SUBJECT: DENIAL, WELLFIELD UNIT 1 GROUND-WATER RESTORATION
APPROVAL, CROW BUTTE RESOURCES *IN SITU* LEACH FACILITY,
LICENSE NO. SUA-1534 (TAC No. L52376)

Technical Evaluation Report

FACILITY: Crow Butte Resources *In Situ* Leach Uranium Project, Chadron, Nebraska

FIGURE 1. Unit 1 Radium-226 Measurements

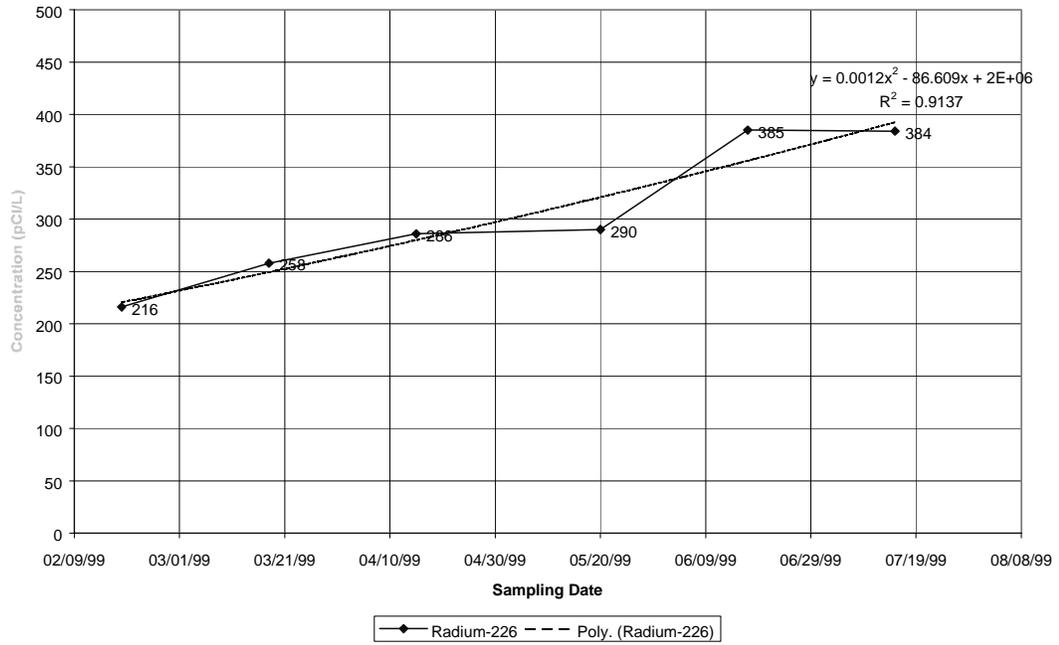
1. **Finding:** Staff’s analysis indicates that concentrations of ammonium, iron, radium-226, selenium, total dissolved solids, and uranium show strongly increasing concentration trends over the stability monitoring period. These trends indicate a reasonable likelihood that license limits would be exceeded in the near future. Other constituents appear to have reached stability, or exhibit such a weakly increasing trend that stability is not a concern. Figures 1, and 2, provide examples of strongly increasing concentration trends in the monitored data during the stability monitoring period. These increasing trends represent a particular concern when a constituent has been restored to the secondary restoration goal, as these two examples were. The secondary restoration standards are greater than the pre-operational baseline concentrations, but are considered protective of the adjacent aquifer beyond the limits of the U.S. EPA designated aquifer exemption boundary. Increasing trends that indicate a potential future exceedance of baseline limits do not represent an immediate concern, since the secondary limits are higher than the baseline limits and are considered protective. Figures 3, and 4, illustrate two constituents that appear to have stabilized during the stability monitoring period. Although Figure 3, shows an increasing trend, this trend is not significant. Figure 4 shows a strongly increasing trend in the early measurements, but the trend dissipated by the time the later data were collected.

1. The licensee's request for Unit 1 wellfield restoration approval should be denied.
2. Decommissioning of Unit 1 should not proceed at this time.
3. Stabilization ground-water monitoring in Unit 1 should be restarted immediately at the monitoring locations described in the January 10, 2000, Restoration Report. The ground-water should be sampled and analyzed for the constituents listed in License Condition 10.3B, SUA-1534, on a schedule of at least 14 days apart. The wellfield restoration shall be considered stable if four consecutive sampling episodes show no strongly increasing concentration trends for all monitored constituents, on a wellfield average, as described in Section 6.1.3, "Standard Review Plan for *In Situ* Leach Uranium Extraction License Applications," NUREG-1569.
